Access Compliance Report

Public Rights-of-Way

(Curb Ramps)

Intersection ID: 5741	Main Street: MALLARD_CREEK_RD	Cross Street: NEVIN_RD	Location: S
ADA ID: C188C04EDFC9	Ramp Type: MedianPerp	Initial Pass/Fail: Fail	Overall Compliance: No
Severity Score: 12.5			
Codes/Mitigation Info/Possible Solution		Field Measurements/Component Compliance

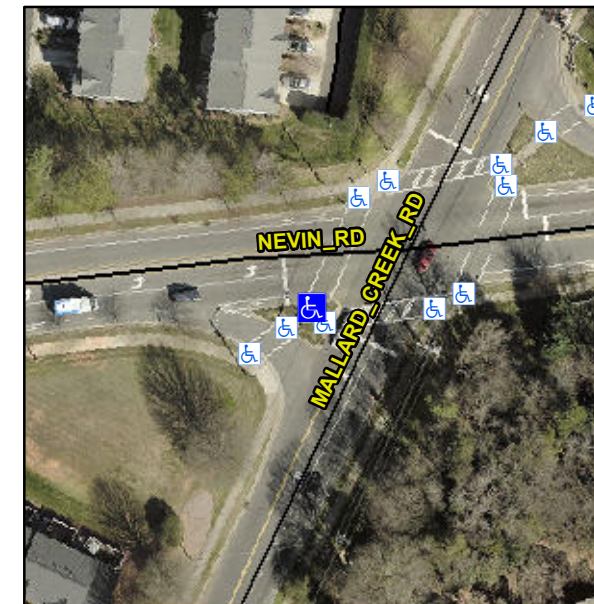
Not Found, R304.2.2

Compliance	Description	Data	Compliance	Description	Data
N/A	Ramp Length (in)	36.0	No	Ramp Slope (%)	8.4
Yes	Ramp Width (in)	80.0	Yes	Ramp XSlope (%)	2.0
N/A	Flare Type LT	N/A	N/A	Flare Type RT	N/A
N/A	Flare Slope LT (%)	N/A	N/A	Flare Slope RT (%)	N/A
N/A	Flare Traversable LT?	N/A	N/A	Flare Traversable RT?	N/A
N/A	Landing Length (in)	N/A	N/A	DWS Provided?	N/A
N/A	Landing Width (in)	N/A	N/A	DWS Contrast?	N/A
N/A	Landing Slope (%)	N/A	N/A	DWS Length (in)	N/A
N/A	Landing X Slope (%)	N/A	N/A	DWS Full Width?	N/A
N/A	Landing Curb? (Y/N)	N/A	N/A	DWS Offset (in)	N/A
N/A	Shared Landing?	N/A			
N/A	Gutter Ponding?	N/A	N/A	Gutter Slope (%)	N/A
N/A	Gutter Lip Ht (in)	N/A	N/A	Gutter X Slope (%)	N/A
N/A	Painted X Walk1?	Yes	N/A	Painted X Walk2?	N/A
	X Walk 1 Direction	To NE		X Walk 2 Direction	N/A
N/A	X Walk 1 Width (in)	139.0	N/A	X Walk 2 Width (in)	N/A
	X Walk 1 Slope (%)	0.7		X Walk 2 Slope (%)	N/A
	X Walk 1 X Slope (%)	1.3		X Walk 2 X Slope (%)	N/A

Remove & Replace Entire Ramp.
